Chapter 6
CRITIQUE OF FUTURE DEVELOPMENT PROPOSALS
FOR THE ALBANY WATERFRONT
Michele Emerson

Figure 2. Central Park Plan.

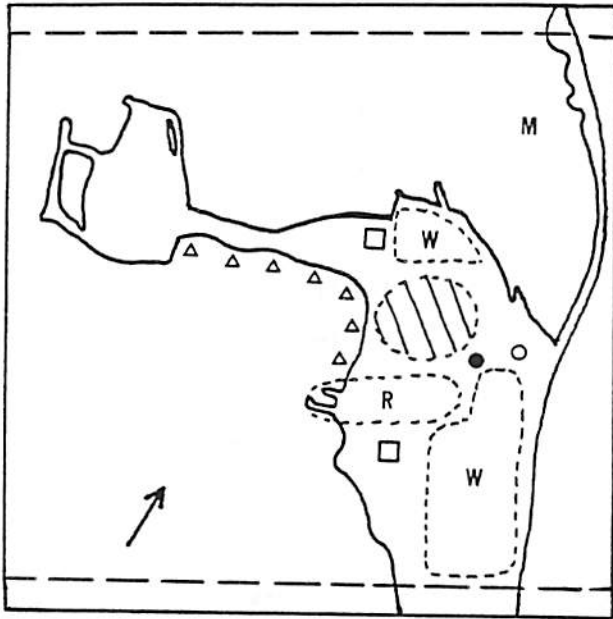
The Central Park Plan: The Central Park Plan created by the Albany Waterfront Committee (see Figure 2) emphasizes an initial phase of development beginning with the construction of workplaces and a hotel along the Plateau, with later development in the Infield and Bowl areas. Workplaces could include offices, small industry, and research and development establishments. The later development phase consists of additional worksites situated along the freeway, a second hotel on Fleming Point, a community center, a theater, and a retail shopping mall which is built to the shoreline and connected to a major pier.

This plan is composed of approximately half commercial development (76 acres), and half open space (65 acres). The majority of the open space is contained in a circular park located in the Bowl area. The Beach Cove and Neck will be devoted to water-oriented recreation, such as small-craft boating and fishing. Most of the shoreline has been left undeveloped for compliance with the State Shoreline Park.

Access to the waterfront now is at best minimal, especially for pedestrians. The California Department of Transportation plans for future development of bike trails and pedestrian walkways to the shore, but has not yet committed itself to a construction deadline. Each of the three plans allows the Neck and Beach Cove to remain as an unbroken stretch of open space, which will be maintained as part of the East Bay Shoreline Park. To provide a continuous approach to these open areas, development in the Entry and Bowl should be discouraged. The Village Hub Plan suggests the placement of a shopping mall in the Bowl area. This will obstruct passage to the water. The Central Park and Santa Fe Illustrative Plans appear to provide the greatest amount of access to the water's edge. Through the use of interior parks they permit an open area which leads directly onto the Beach Cove.

However, neither of these plans is in accord with the State Shoreline park project as they both propose to rebuild the pier near Fleming Point. Ideally, the CDPR desires an unobstructed shoreline trail which reaches all the way to the Emeryville fill in order to provide maximum public access to the shore. The pier will interrupt the continuous shorefront with retail businesses and restaurants.

The Central Park Plan drawn up by the Albany Waterfront Committee appears to be the most feasible proposal. It situates development away from the shore. Most workplaces are contained in the Infield area, which allows the shoreline to be accessible. Moreover, it includes structures which are community-oriented, and may attract the public to the waterfront. The site may then be utilized more frequently.

Most importantly, the impacts to the environment seem to be minimized in this proposal, with the exception of the construction of a retail pier near Fleming Point. There is potential for disturbance of the productive clam beds and other aquatic life in the adjacent tidelands if the pier is rebuilt. Thus, these areas should be closely monitored prior to and after restructuring the pier. Changes in the current zoning provision should be made with the Bay and Mudflat wildlife in mind. Development should be limited to a distance of at least 100 feet from the water's edge. Another positive aspect of this plan is that there will be no residential development. This may enable the surrounding area to support shorebirds and waterfowl without disturbance.

Figure 3. Village Hub Plan.

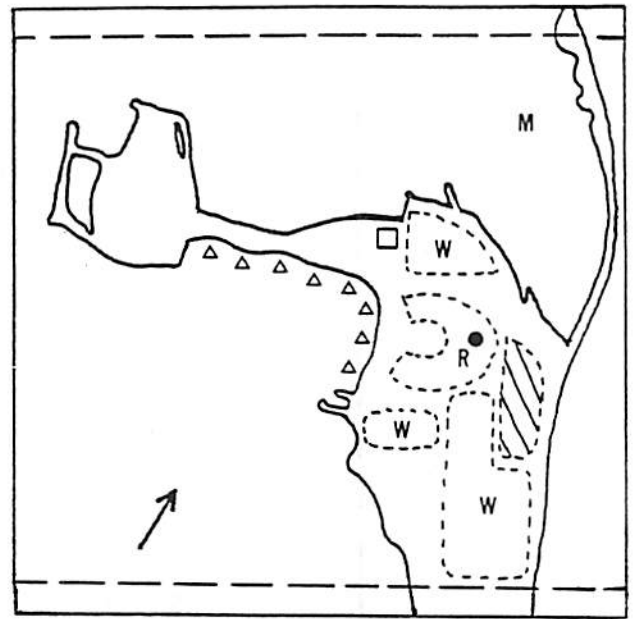
The Village Hub Plan: The Albany Waterfront Committee's Village Hub Plan (see Figure 3) proposes 81 acres of commercial development with 60 acres devoted to open space. The major focus of this concept is a horse-shoe shaped, marina-oriented shopping area with a community center, and a public community plaza in the center. Activity will be concentrated towards the Bowl area. Again, construction of a hotel is proposed on the Plateau, while the entire Inland Field will be worksites. The Beach Cove and Neck are reserved for small-craft boating and fishing, while a recreational sports facility is placed on the south end of the Entry.

Parkland and open space in the interior of the waterfront are necessary for recreational activities requiring wind protection, such as tennis and baseball. However, these interior spaces should not be the only ones available; people should have a choice between a variety of waterfront recreation areas. The Village Hub Plan falls short in this regard as its only recreation area is located on a small portion of the Entry near the freeway. The other plans have more ample park sites.

Figure 4. Santa Fe Illustrative Plan.

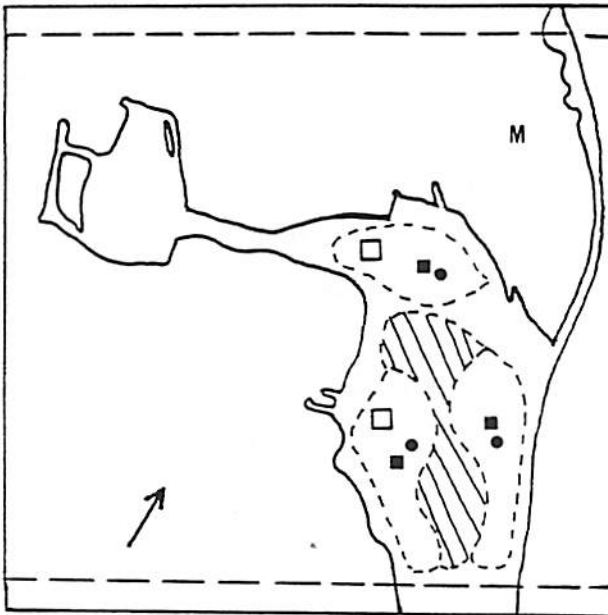
The Santa Fe Illustrative Plan: Santa Fe envisions a waterfront that is half parkland (72 acres), with three distinct development centers styled as knoll-top villages dispersed around the site (70 acres) (see Figure 4). In the center of each neighborhood will be situated a community square. This proposal differs from the others in that residential areas will be integrated with office and specialty retail space. Plans call for one- and two-story buildings facing the shoreline, building up to higher, more concentrated development in the interior of the neighborhoods.

Two to three hotels with approximately 500 rooms each have also been proposed. The buildings on the Plateau will be no more than six floors, and for other areas they will be no higher than the race

track grandstand (Bangsberg, 1985). The entire shoreline will be maintained as a continuous bicycle and hiking trail of varying width, with the exception of the pier near Fleming Point, which will be reconstructed and lined with small retail shops. Again, development will occur in two major phases.

Presently, the view westward across the Plateau is extraordinary. Views across other parts of the waterfront are also excellent, although the grandstand at 100 feet above sea level blocks a portion of the view (Grote, 1986). If the Santa Fe Plan is adopted by the City Council, the proposed six-story hotel will greatly reduce views of the Bay; additional buildings situated along the shoreline would almost eliminate them. A thorough visual impact study should be completed before a plan is accepted to determine heights which will not obstruct lookouts.
